Re: Technical Revision Request - File No. M-2011-028, Animas Glacier Gravel Pit

**ANIMAS GLACIER GRAVEL PIT  
DRAINAGE REPORT – Amendment 1**

**ANIMAS GLACIER BASIN MAP #2**  
**REVISID - 01-22-2014**

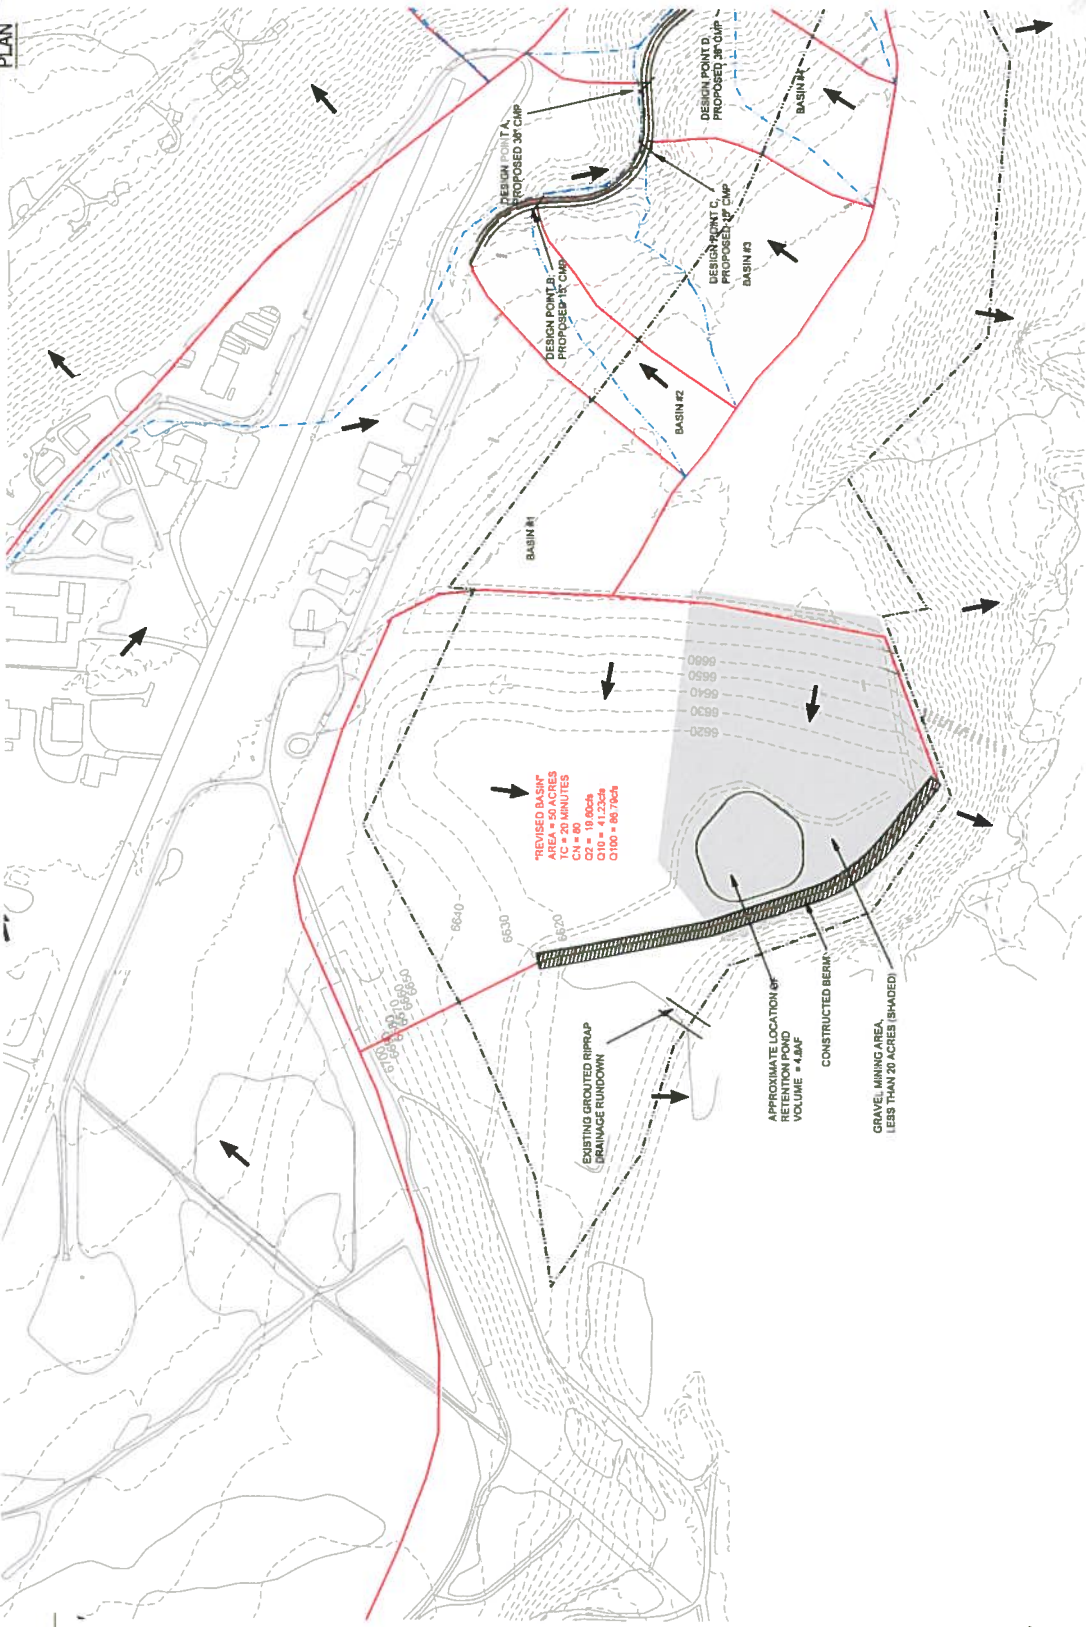
As shown on the attached site plan, the northern extent of the property will remain unaffected. Stormwater drainage across this stretch will reach the existing grouted rundown structure unencumbered by any development or soil disturbance. A perimeter berm was designed to extend along the western rim of the property to the north and east. It is located south of the grouted rundown structure. Based on the existing topography this berm will form a basin, isolating areas to be developed and/or affected from the unaffected area to the north.

As Constructed, the retention pond and the berm will eliminate the originally proposed Grass Lined Swale A, which was intended to route the undisturbed drainage basin around the mined pit area. This change will increase the contributing detention basin to the gravel pit retention pond to approximately 50 acres. The revised basin has been modeled and will have the following characteristics.

"REVISED BASIN"  
 AREA = 50 ACRES  
 TIME = 10 MINUTES  
 CIP = 36"  
 C2 = 19.0028  
 C10 = 41.2324  
 C100 = 66.7304
